Project 2020 Design Phase

St. Nicholas Greek Orthodox Church

Townhall

15 September 2019

Basic Rendering

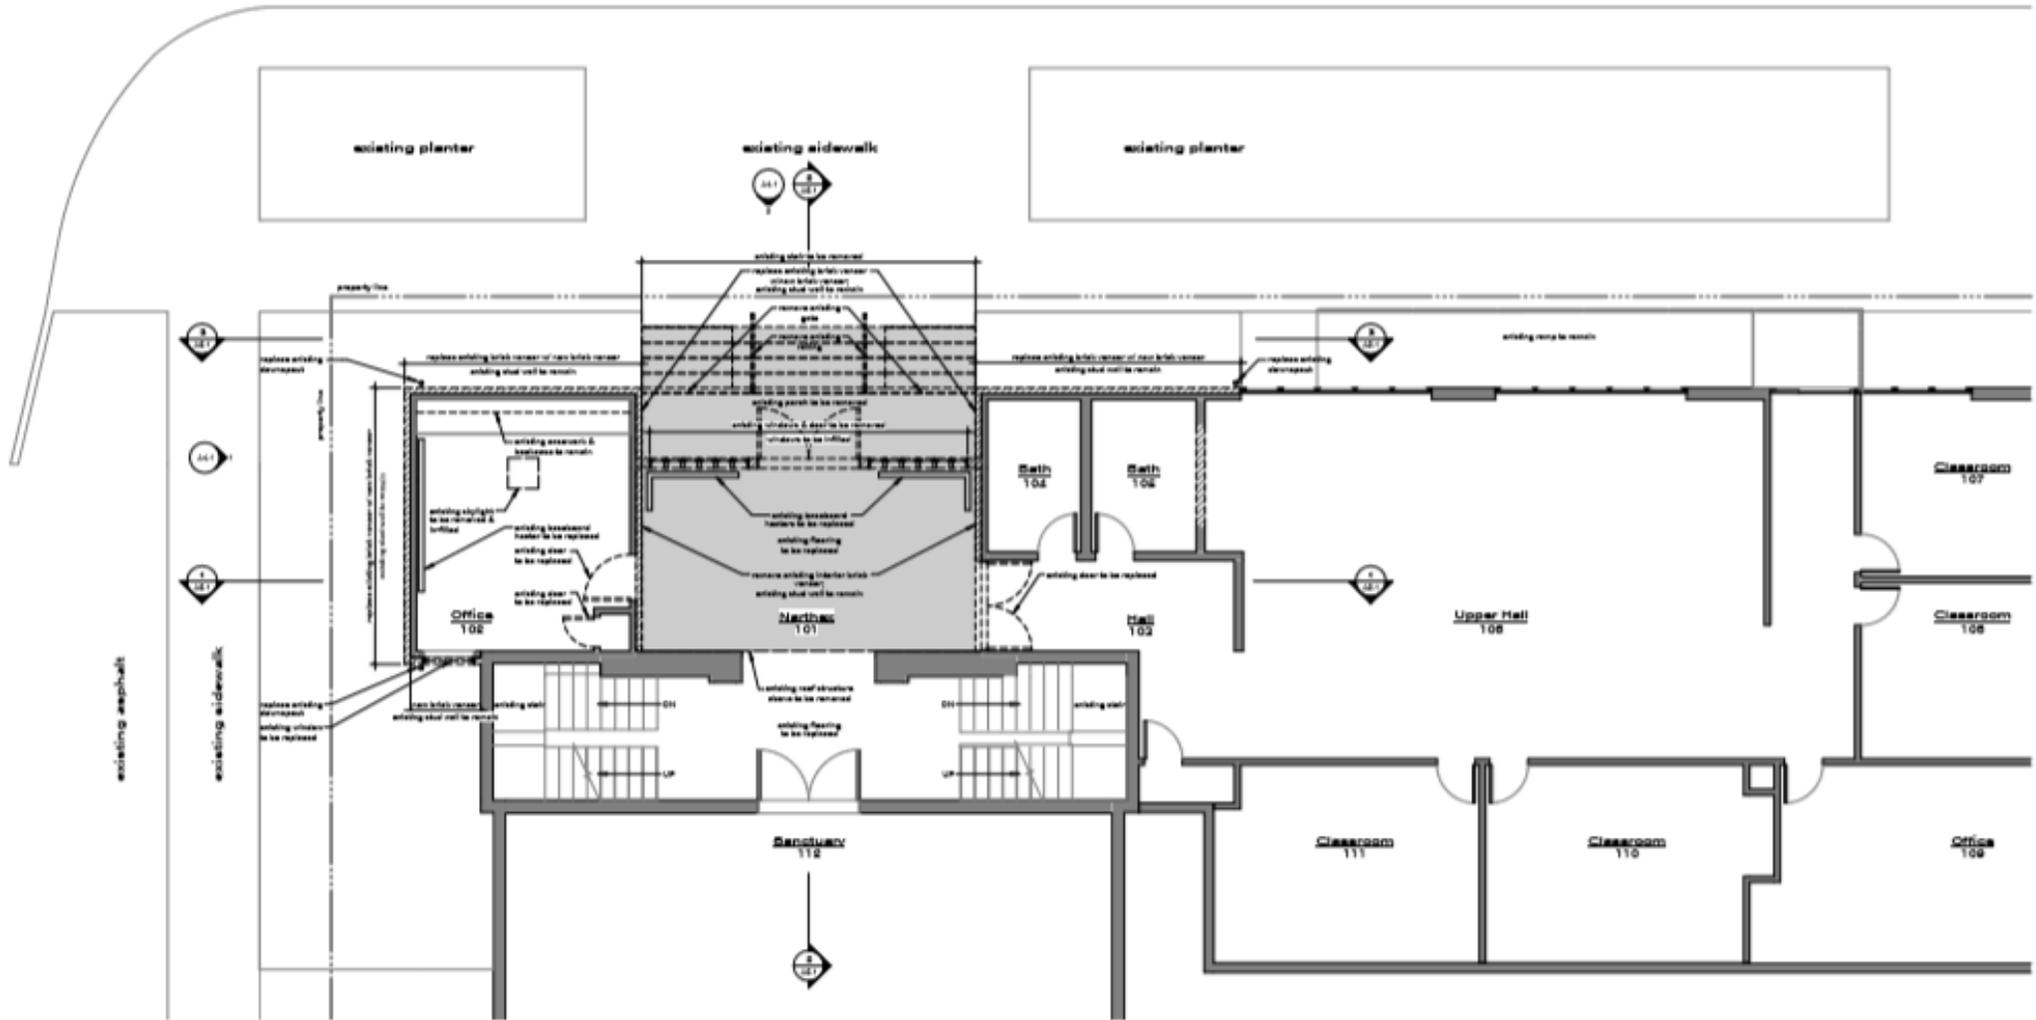
Several comments were received about the initial design which included marble tile at the exterior front façade. This has been changed to brick veneer with accent trim to more closely align with the existing structure, as most commenters suggested.
